Product Change Notice

PCN Ref Nº: N6 and N6R marking change

INVOLVED ARTICLES: N6 and N6 R

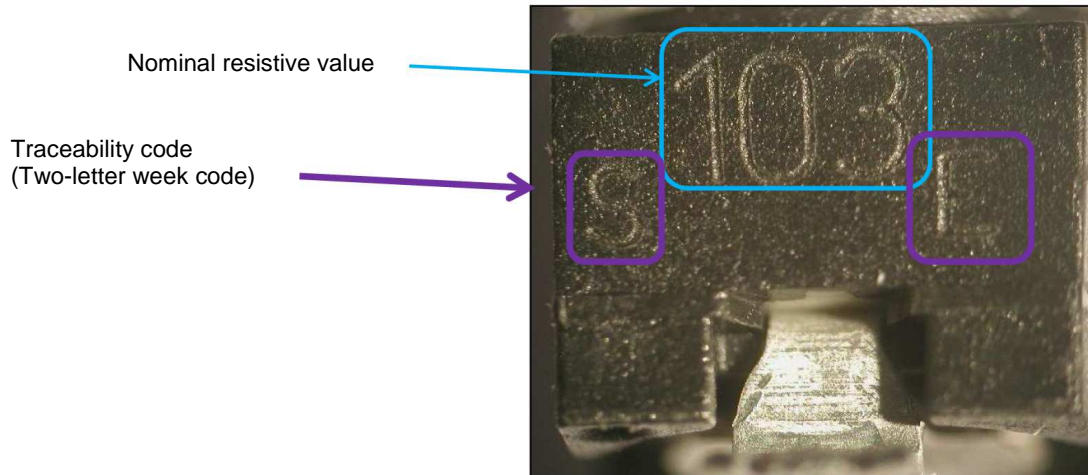
Please be informed that we are upgrading the N6 and N6R series marking pattern to match the scheme used in the PT-6, PS-6, PSX-6, PT-10, PTC-10, PS-10, PSX-10, PT-15, PTC-15, PS-15 and PSX-15 products.

Old marking: Three-digits value (third digit represents the number of zeros to follow) and two letters for date traceability. Example J101F

New marking: Value, taper, year, week, tolerance, optional E for long life
Example: 100427ME

Old marking example.

New marking example.

Notes: custom/special products might have a different marking scheme. Taper will be omitted if linear "A" type. If special taper, tolerance will be omitted.

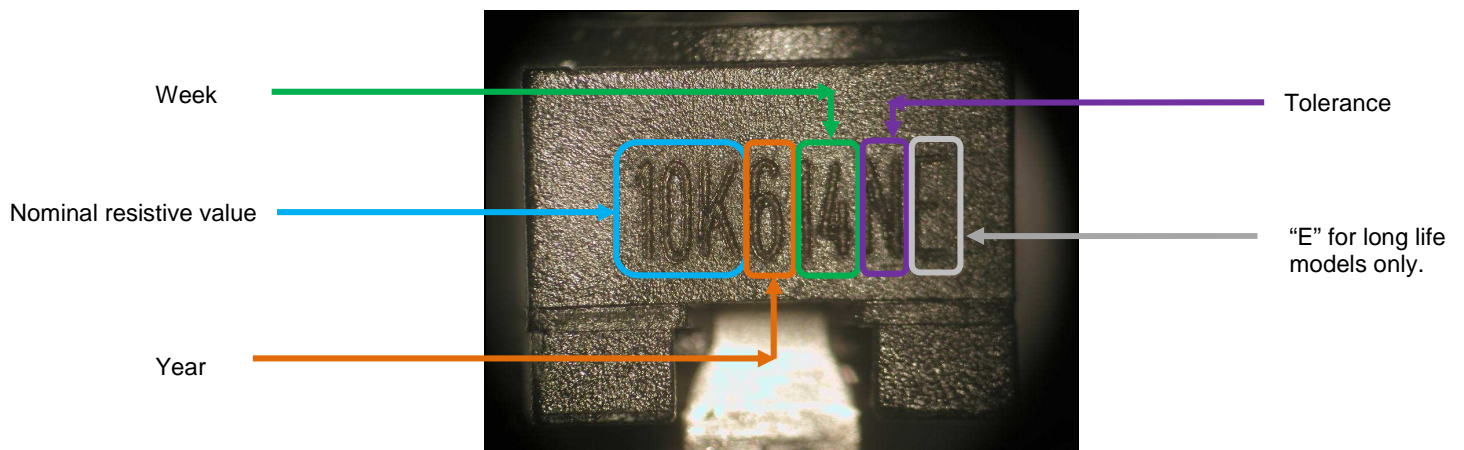
Visual aid – old marking

Visual aid – new marking
